**APPROACH TO RESOLVING  
RAI LETTERS 77 AND 79**

**Fermi 3 COLA**

**November 29, 2012**

Figure 5a FRS - Y-Direction from SER-DTF-008 (Confirmatory Analysis with Backfill)

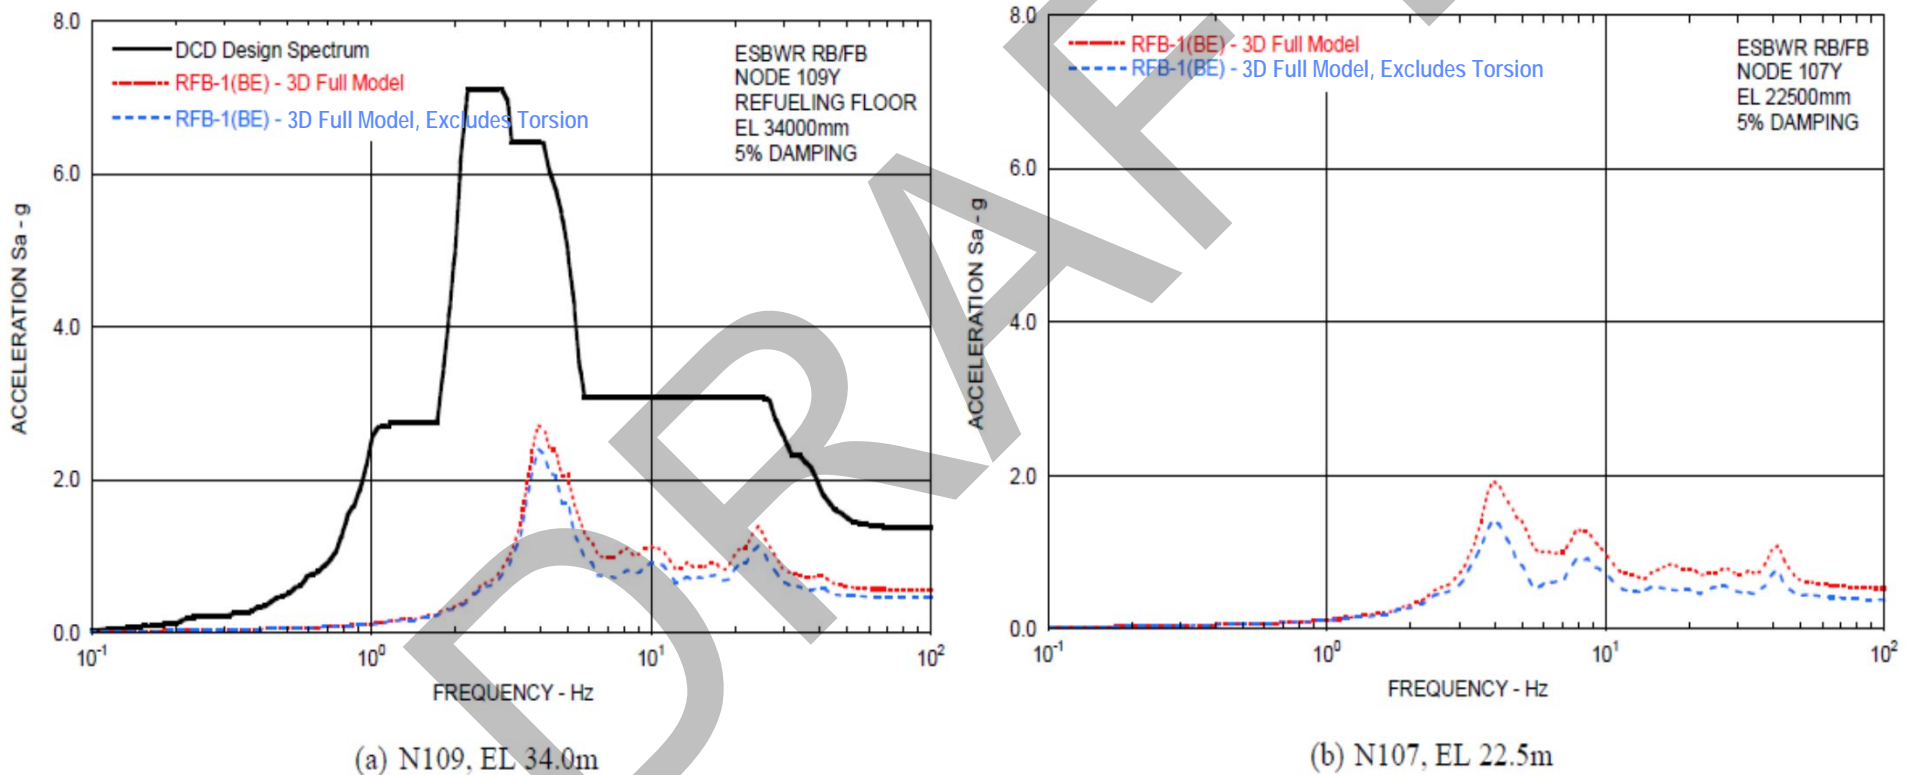
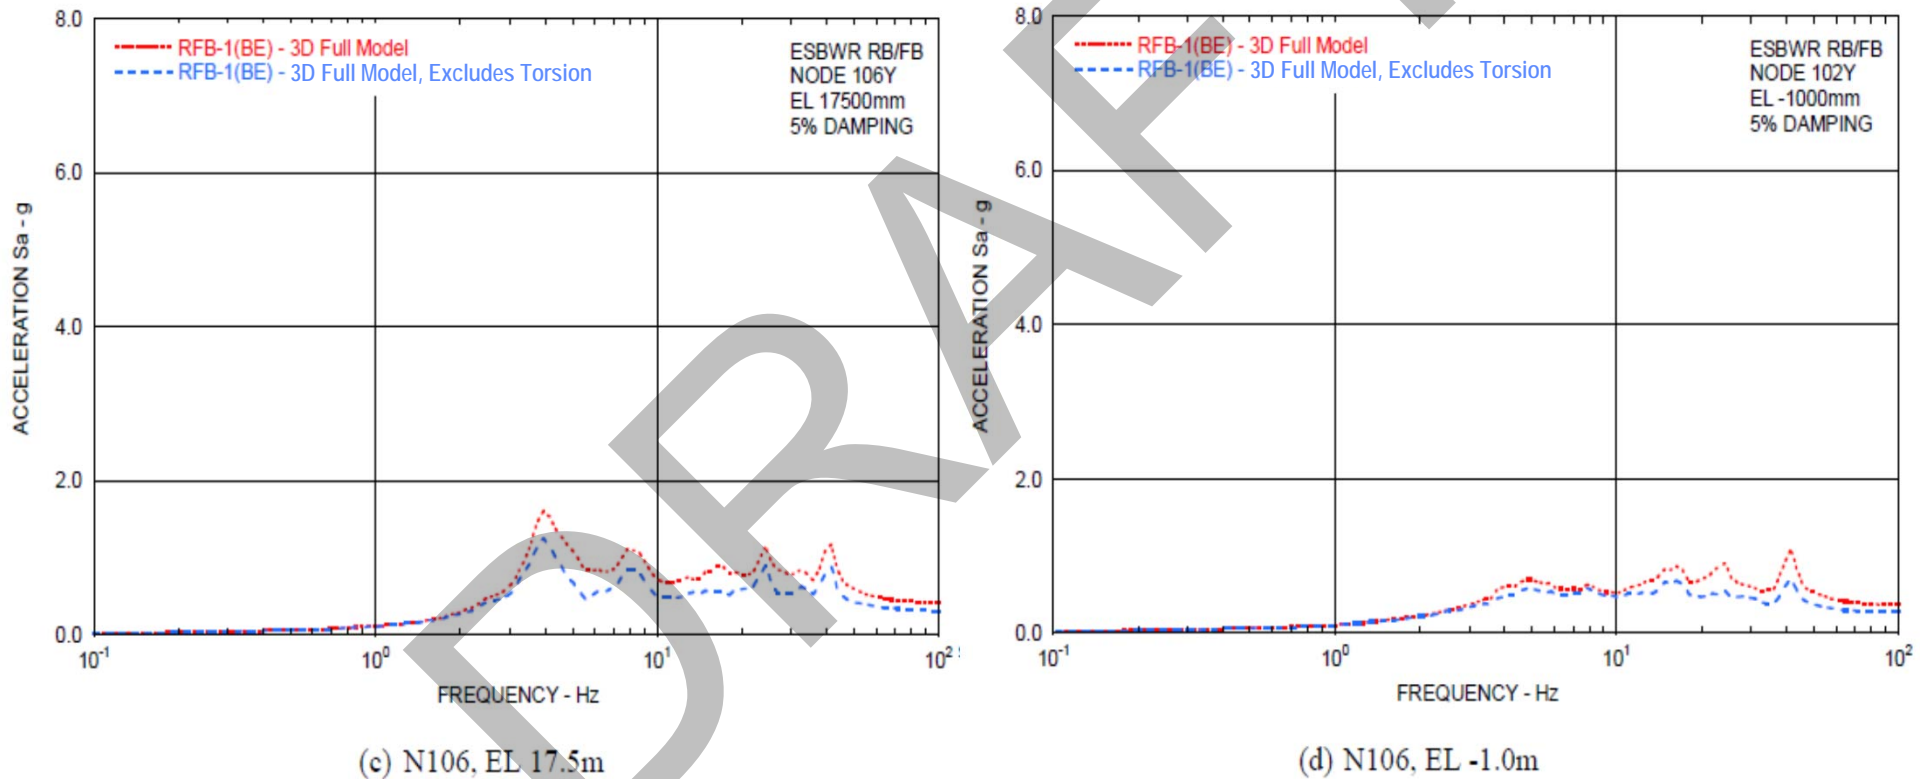
- The calculated floor elevations are selected at nodes N109, N107, N106 and N102 (Figure 1)
- Figures 2 through 5 show the comparison of the FRS between the 3D Full Model with and without the torsion components

- Figures 2 and 3 show the results from the Licensing Basis Analysis for the X and Y directions, respectively
  - Figures 4 and 5 show the results from the Confirmatory Analysis with Backfill for the X and Y directions, respectively

- The differences in FRS in X direction are small
- The difference of FRS in Y direction are larger but not significant
